Modification procedure AE 5080 / 5280 FM CEPT from FM only into AM/FM

Albrecht Electronic GmbH

Modification procedure AE 6080 FM from FM only into AM/FM

Modification AE 4144 FM from FM only into AM/FM

Modification FM only into AM/FM:

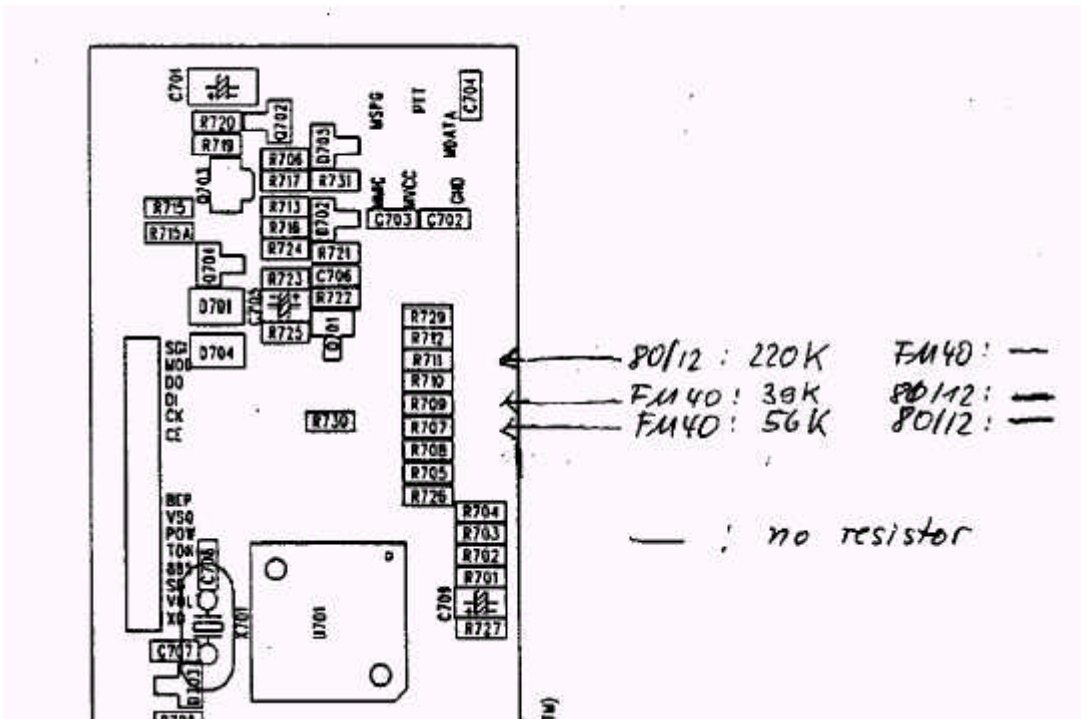
Delete resistor R 707 (56 k) This modification allows AM/FM instead of FM only.

Frequency range (40 channels) is not changed by this procedure.

If another frequency range is desired, further modification may be necessary according to following table:

40 /40	R 709 = 39 k
	R 711 not installed
80/12	R 709 not installed
	R 711 = 220 k
Extended CB	R 709 39 k
	R 711 100 k

The resistor positions can be found in one line between CPU and MIC socket on the front panel board. The sequence is (counted from CPU to MIC socket position):

(R 726-R705-R708-R707-R709-R710-R711-R712-R729)

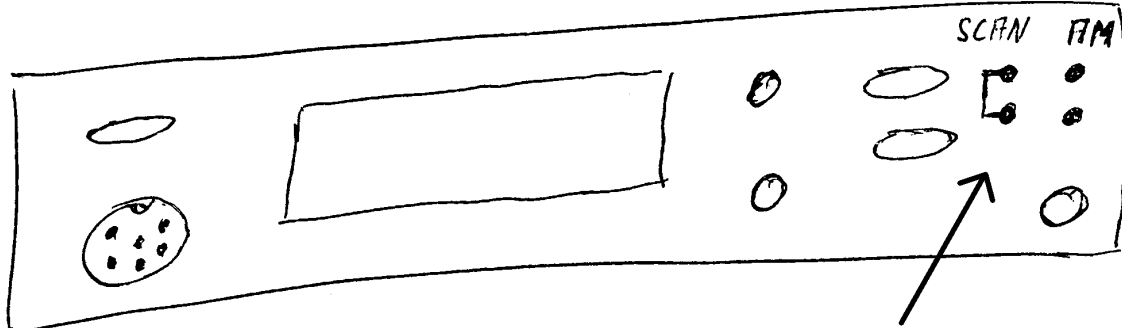
On the front panel PCB You will find jumpers just besides the switches.
There is a jumper named "SCAN" , which is inserted in the FM only version.

Please open this jumper and solder a new jumper into the holes named "AM"
